COMPARATIVE ELEVATION SET

THE BRADFORD

BELMONT RESIDENTIALS, LLC  
NEEDHAM, MA

PLANNING BOARD PRESENTATION

### BUILDING 1 - THE WINSLOW

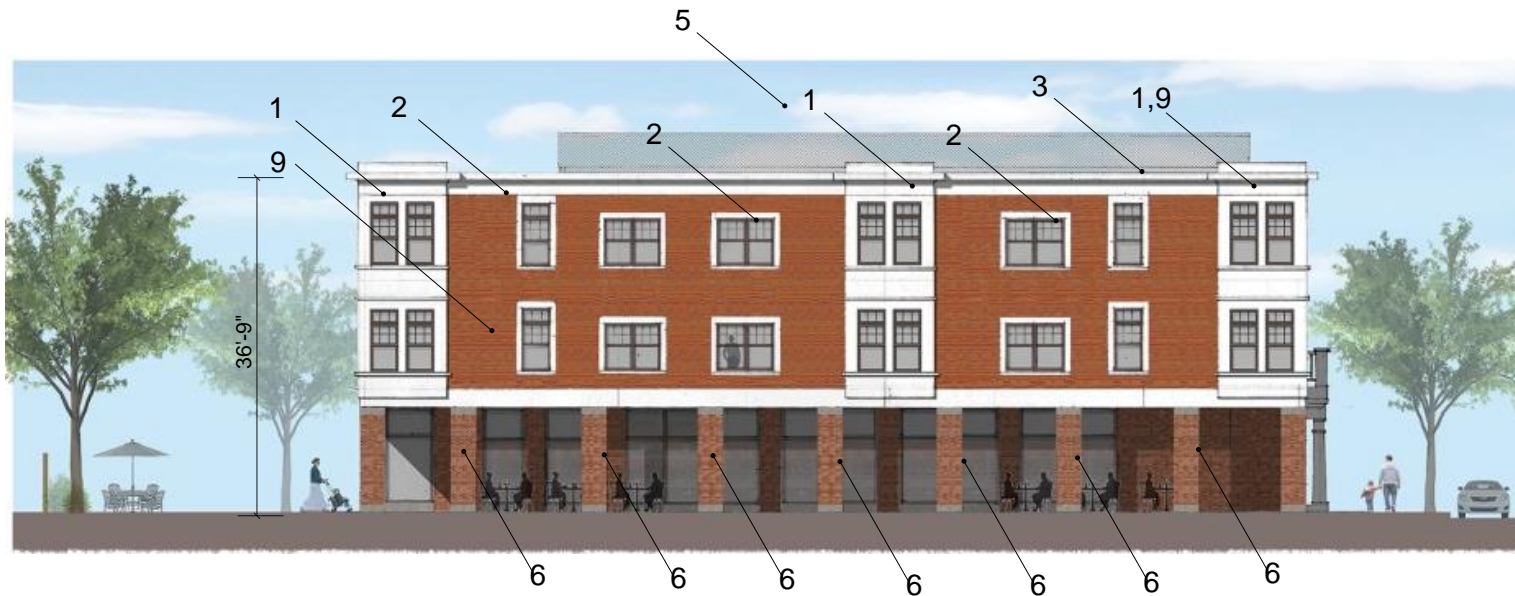
1. Moved bays. Aesthetic and programmatic decision, typical all elevations.
2. Adjusted window combinations. Programmatic decision, typical all elevations.
3. Reduced and centered large cornice to entry bay. Aesthetic decision.
4. Eliminated common roof deck room and deck. Programmatic decision
5. Eliminated elevator stair head house. Programmatic decision.
6. Widened brick piers. Aesthetic decision.
7. Railing is now shown. No change.
8. Entry doors reconfigured. Aesthetic decision.
9. Change to building footprint at 2<sup>nd</sup> and 3<sup>rd</sup> floor. Programmatic decision to conform to corner plan layout.

## BUILDING 2 - THE POMONA

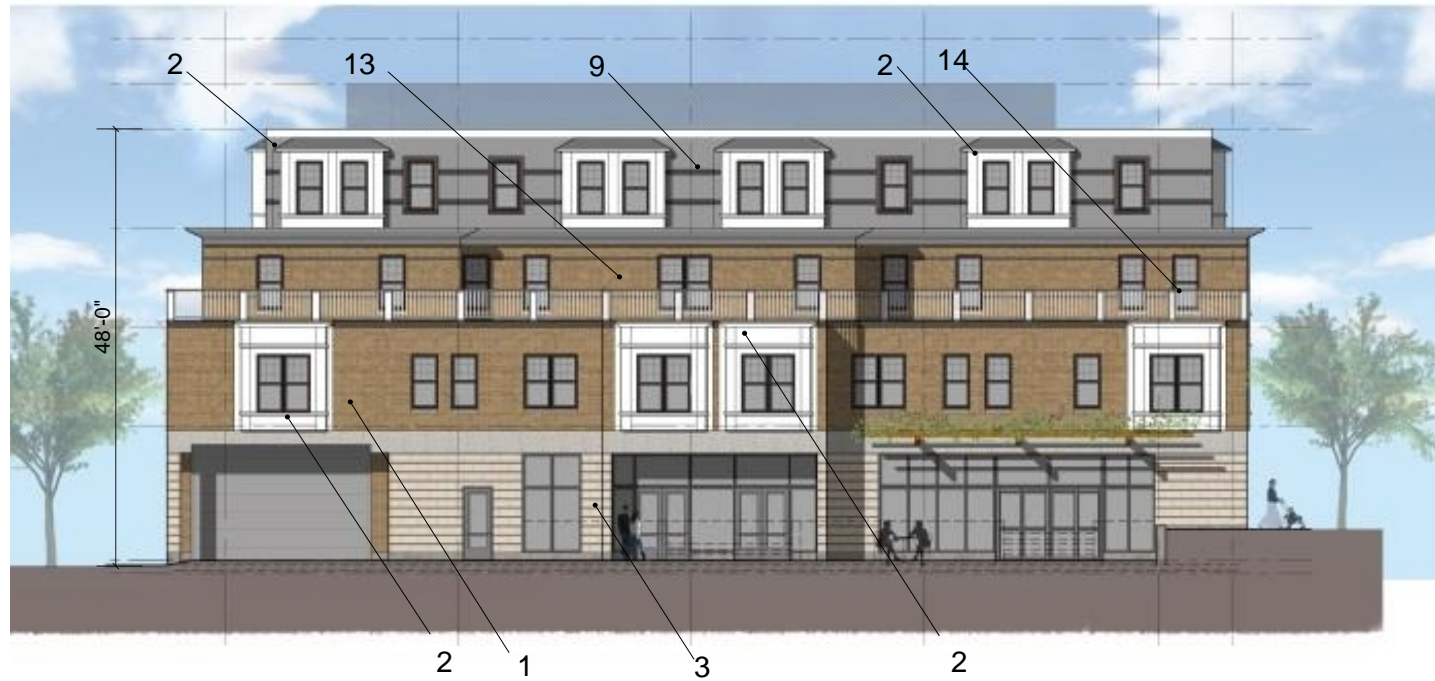
1. Change 3 coat stucco system to brick tile system at 2<sup>nd</sup> and 3<sup>rd</sup> floors. New owner's building standard to avoid stucco. Typical at all elevations.

2. Established bays and bay alignments. Aesthetic decision.
3. Extended rusticated limestone at ground floor at all facades. Aesthetic decision.
4. Simplified ornamentation on Corner element. Aesthetic decision.

5. Substituted Clock for decorative emblem. Aesthetic and programmatic decision.
6. Eliminated glass and steel entry canopies. Aesthetic decision.
7. Altered footprint at 2<sup>nd</sup> floor. Programmatic decision to conform to corner plan layout.

8. Added detail in brick with tile infill and colored brick bands. Aesthetic decision.
9. Reduced number of horizontal shadow reveals at 4<sup>th</sup> floor. Aesthetic decision.

10. Substituted Cement fiberboard panels for stucco system at "court" elevations. Aesthetic decision.
11. Reduced storefront glazing at loading dock. Programmatic decision.

12. Modified Grades at building. Required by new site information.
13. Repositioned windows. Programmatic decision to conform to plan layouts.
14. Simplified Rail system. Aesthetic decision.

PROPOSED ELEVATIONS (HORNE ROAD)

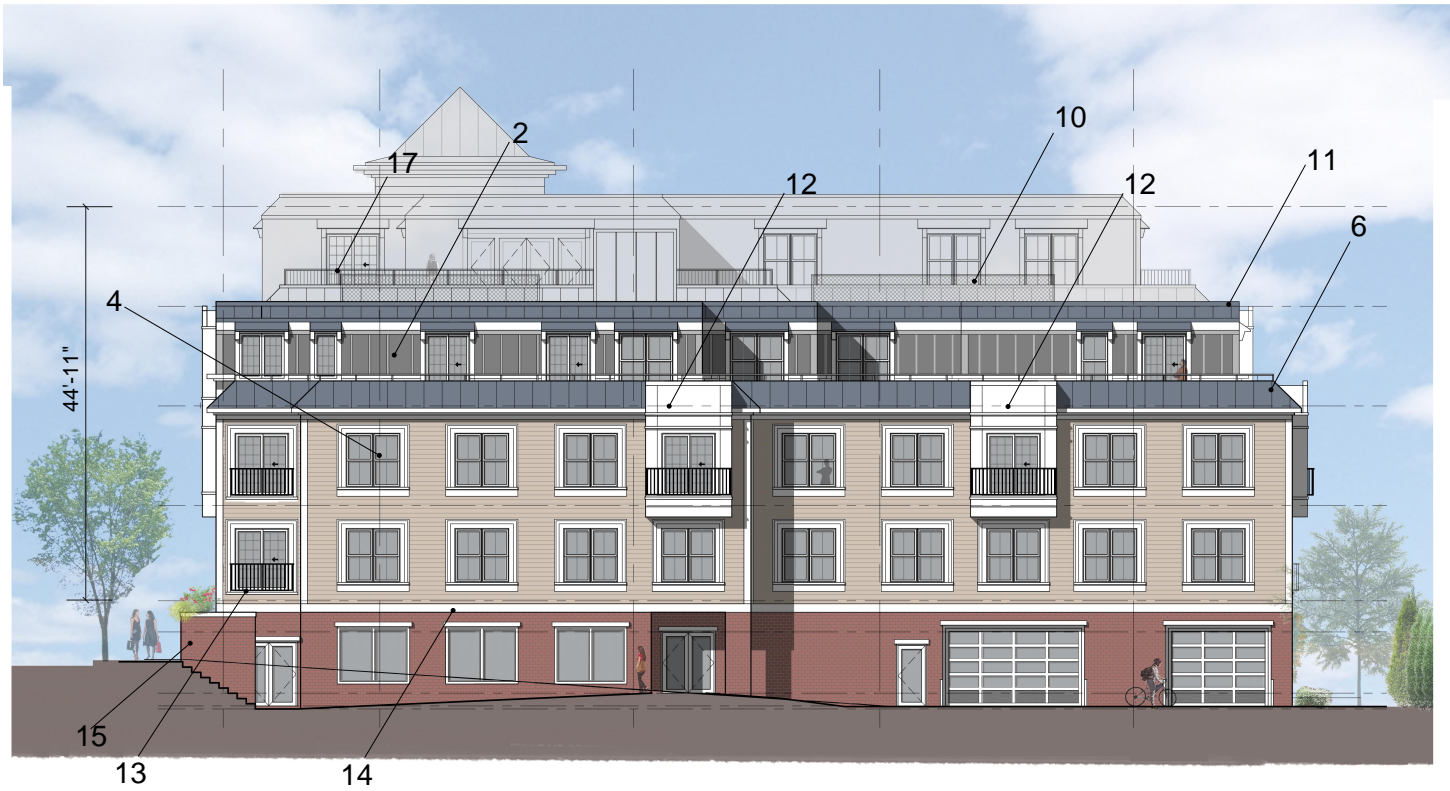
1. Increased cornice at tower roof. Aesthetic decision.
2. Substituted "Board and Batten" finish system for Stucco on tower. Aesthetic decision and new owner building standard.

3. Increase brick on tower base. Aesthetic decision.
4. Increased window height from 5' to 6' and Increased window trim profile. Aesthetic decision.
5. Reduced the amount of roof with a new board and batten treatment. Aesthetic decision.

6. Changed Color of mansard gambrel Roof. Aesthetic decision.
7. Made wood columns brick piers. Aesthetic decision.
8. Reconfigured entry tower. Aesthetic decision.

9. Raised Cornice line to allow for 6' windows on floor below to fit more comfortably on facade. Aesthetic decision.
10. Mechanical screen wall, setback to reduce visibility

11. Reduce apparent building height by eliminating sloping parapet at this location [typical – middle part of building]. Aesthetic decision.
12. Reconfigured bay window roof lines to follow entry bay. Aesthetic decision.

13. Extended wall in corner to facilitate plan. Programmatic decision.
14. Added skirt board above brick. Aesthetic decision.
15. Reconfigured planter. Programmatic decision.

16. Changed door to Window. Programmatic decision.
17. Lowered sloped parapet roof to match upper level roof lines and added hand rail to meet code. Aesthetic decision

18. Modified grades at building. Required by new site information.
19. Delete stair penthouse
